NUREG-1740

Voltage-Based Alternative Repair Criteria

A Report to the Advisory Committee on Reactor Safeguards by the Ad Hoc Subcommittee on a Differing Professional Opinion

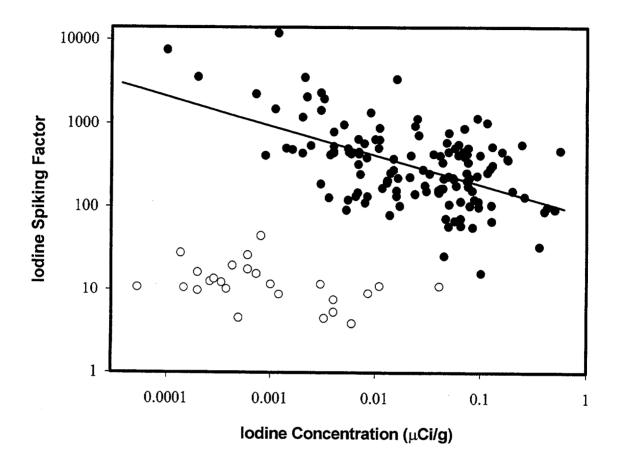
The DPO author contends that the spiking factor used for the accident analyses is too low when the Technical Specification limit on the iodine concentration in the coolant during normal operations has been reduced. He argues that the spiking factor increases with decreasing steady-state iodine concentration. Data collected and reviewed by Atwood and Sattison [17] substantiate the claim made by the DPO author (See Figure 6). A phenomenological understanding of this correlation

The DPO author rightly contends that the iodine spiking factor seems to exhibit a correlation with the initial iodine concentration in the coolant. But, it might be argued that for accident analyses the appropriate spiking factor to use is that found from the empirical correlation using the actual operational iodine concentration rather than the Technical Specifications limit adopted by the licensee, whether it is $1.0 \ \mu$ Ci/g or $0.01 \ \mu$ Ci/g. Such a procedure would be inconsistent with the approaches that have long been used in the analysis of design basis accidents. The Ad Hoc Subcommittee also believes that the empirical, linear correlation of spiking factor with initial iodine concentration to the very low initial iodine concentrations typical of many plants today without explicitly accounting for data uncertainties and variations in the mechanisms that lead to operational levels of iodine in the coolant is without sound technical foundation.

where N = 58 is the number of data points used to construct the correlation. These bounds are indicated in Figure 6 by the dashed lines on either side of the solid line calculated from the correlation.

Completely empirical correlations of the type shown above that do not have a mechanistic underpinning ought not be extrapolated beyond the supporting database. When they are, properly calculated confidence intervals become very large. Worse, predictions can be useless because they indicate greater iodine release than the iodine inventory available for release from one or a few defected fuel rods. The Ad Hoc Subcommittee notes, then, that a simple correlation of spiking factor with initial iodine concentration is not an adequate description of the spiking phenomenon for accident analyses. There have been attempts to develop mechanistic spiking models [19] and these models could be developed further to gain a more realistic understanding of the source terms associated with design basis accidents.
